Addendum No. 1 December 3, 2025

City Project No. 23-068 Package 2 Roads Program Capital Improvement Project

This addendum includes revisions to Plans and Specifications and provides clarifications and answers to questions submitted to the City.

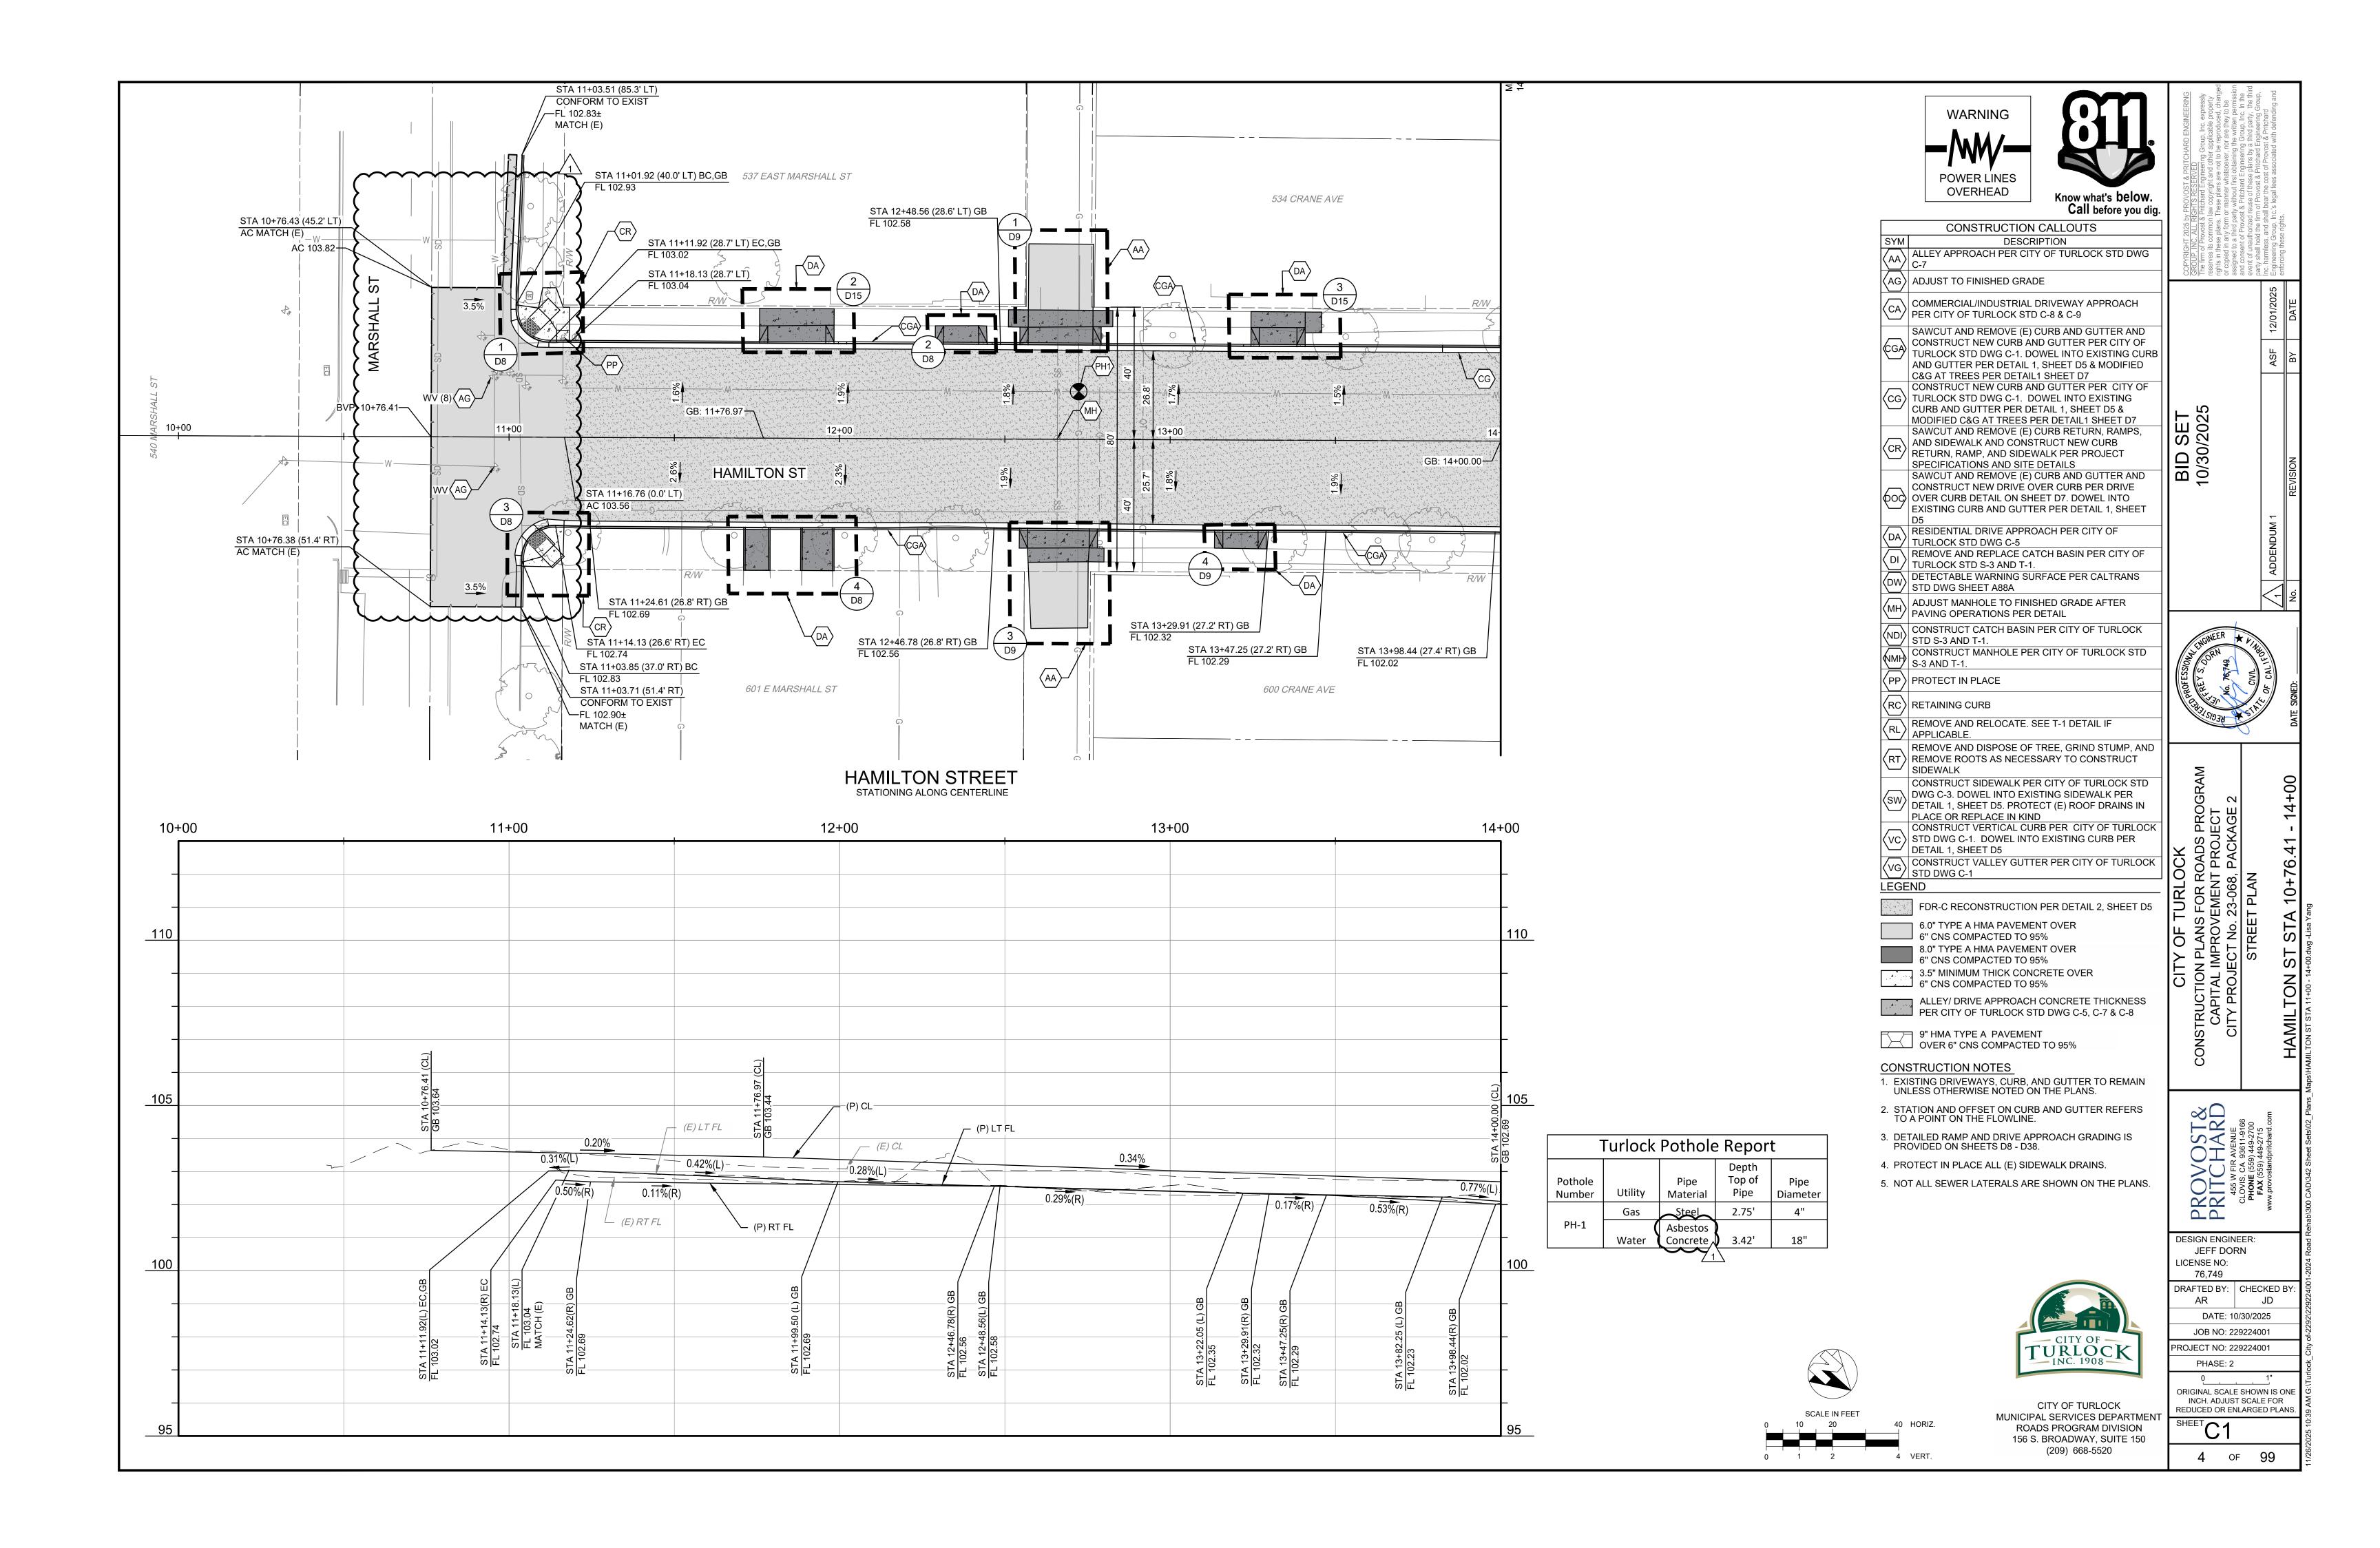
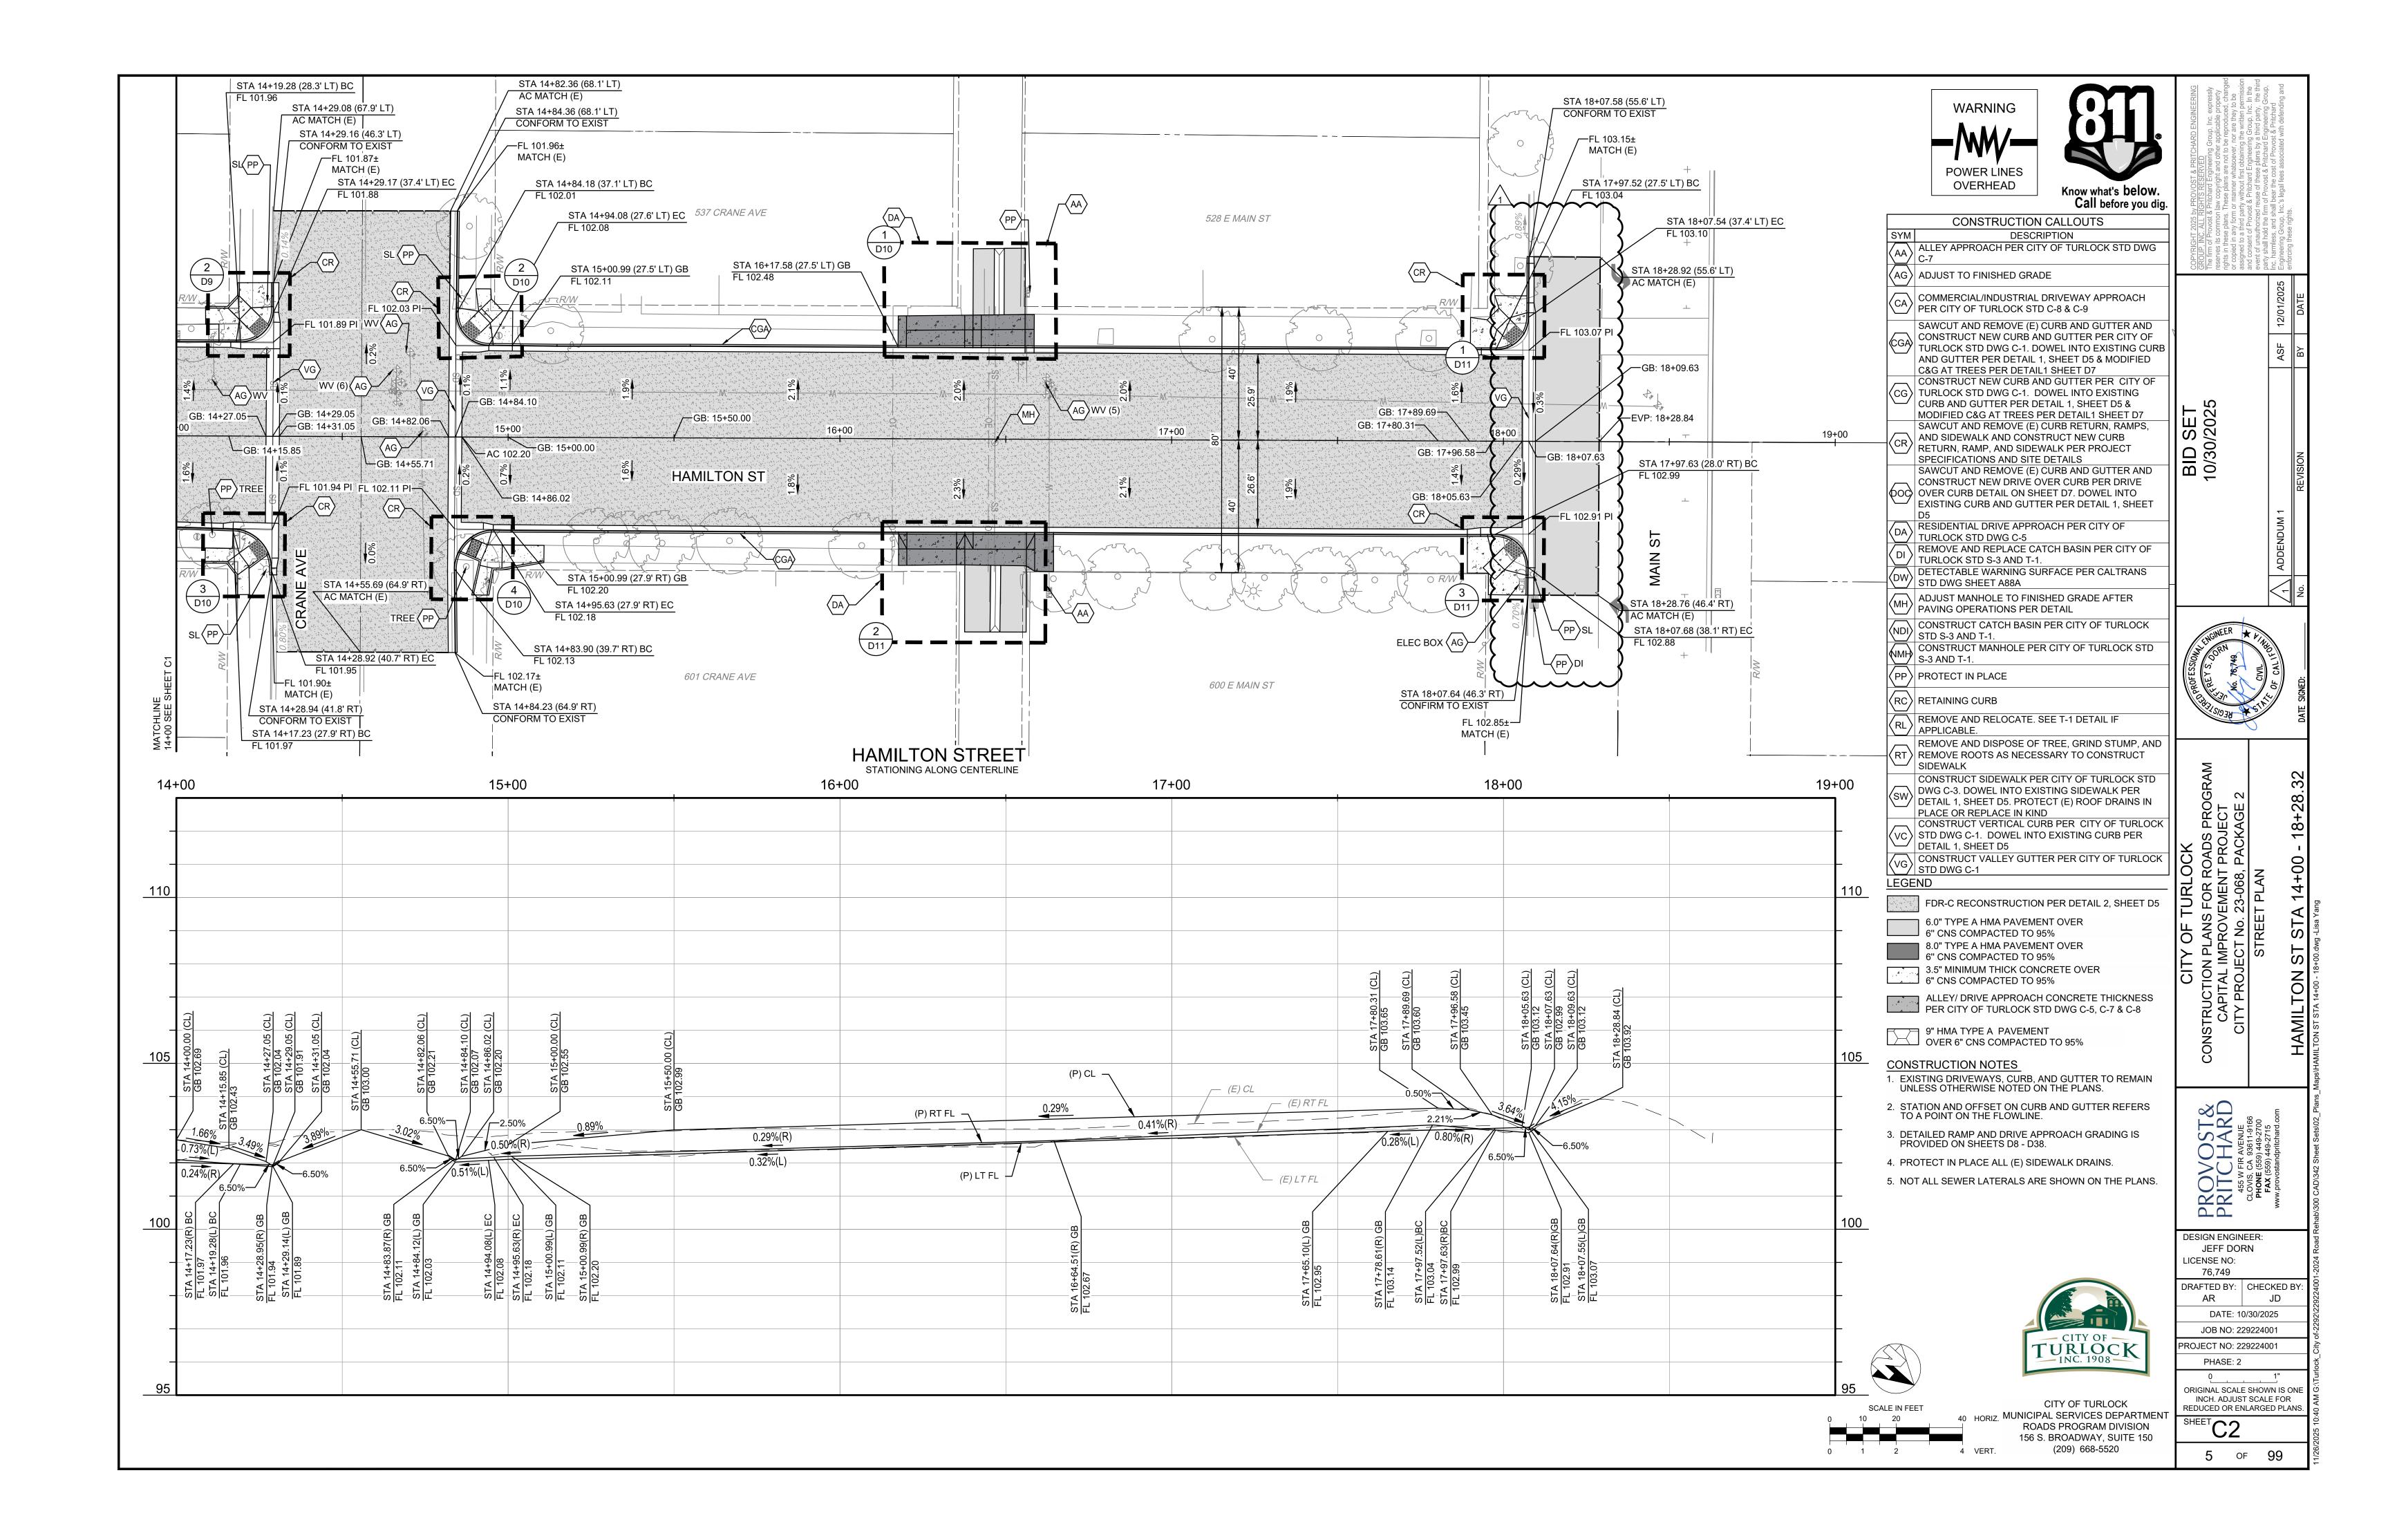
Delete sheets C1-C3 and replace with attached sheets C1-C3 of this addendum. Revisions consist of changing the street rehabilitation method and pothole report table.
